Access Compliance Report

Public Rights-of-Way

Intersection ID: 44689	Main Street: SHANON_DARBY_LN	Cross Street: GENTLE_STREAM_LN	Location: S
ADA ID: D40FFF1392B9	Ramp Type: PerpDiag	Initial Pass/Fail: Fail	Overall Compliance: No
Severity Score: 33.75			
Codes/Mitigation Info/Possible Solution		Field Measurements/Component Compliance

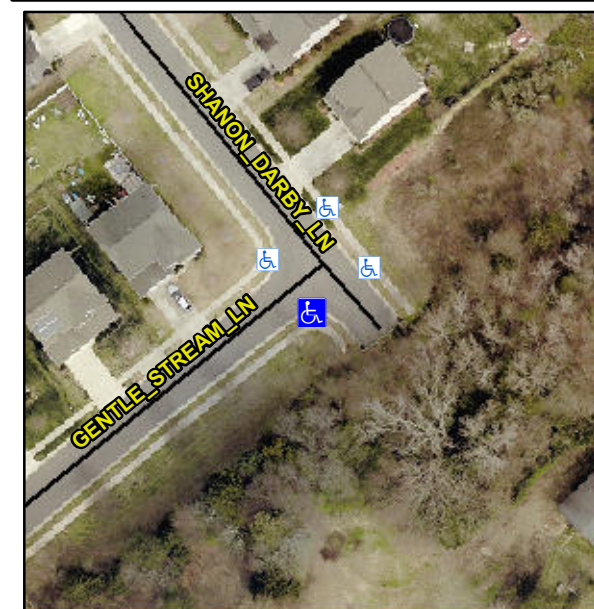
Not Found, R304.5.1, R304.5.3

Compliance	Description	Data	Compliance	Description	Data
N/A	Ramp Length (in)	48.0	Yes	Ramp Slope (%)	5.1
No	Ramp Width (in)	47.5	No	Ramp XSlope (%)	8.9
N/A	Flare Type LT	N/A	N/A	Flare Type RT	N/A
N/A	Flare Slope LT (%)	N/A	N/A	Flare Slope RT (%)	N/A
N/A	Flare Traversable LT?	N/A	N/A	Flare Traversable RT?	N/A
N/A	Landing Length (in)	N/A	N/A	DWS Provided?	N/A
N/A	Landing Width (in)	N/A	N/A	DWS Contrast?	N/A
N/A	Landing Slope (%)	N/A	N/A	DWS Length (in)	N/A
N/A	Landing X Slope (%)	N/A	N/A	DWS Full Width?	N/A
N/A	Landing Curb? (Y/N)	N/A	N/A	DWS Offset (in)	N/A
N/A	Shared Landing?	N/A			
N/A	Gutter Ponding?	N/A	N/A	Gutter Slope (%)	N/A
N/A	Gutter Lip Ht (in)	N/A	N/A	Gutter X Slope (%)	N/A
N/A	Painted X Walk1?	No	N/A	Painted X Walk2?	No
	X Walk 1 Direction	To NE		X Walk 2 Direction	To NW
N/A	X Walk 1 Width (in)	N/A	N/A	X Walk 2 Width (in)	N/A
	X Walk 1 Slope (%)	0.2		X Walk 2 Slope (%)	3.1
	X Walk 1 X Slope (%)	3.8		X Walk 2 X Slope (%)	2.3

Remove & Replace Curb Ramp With Two New Directional Ramps or Equivalent.
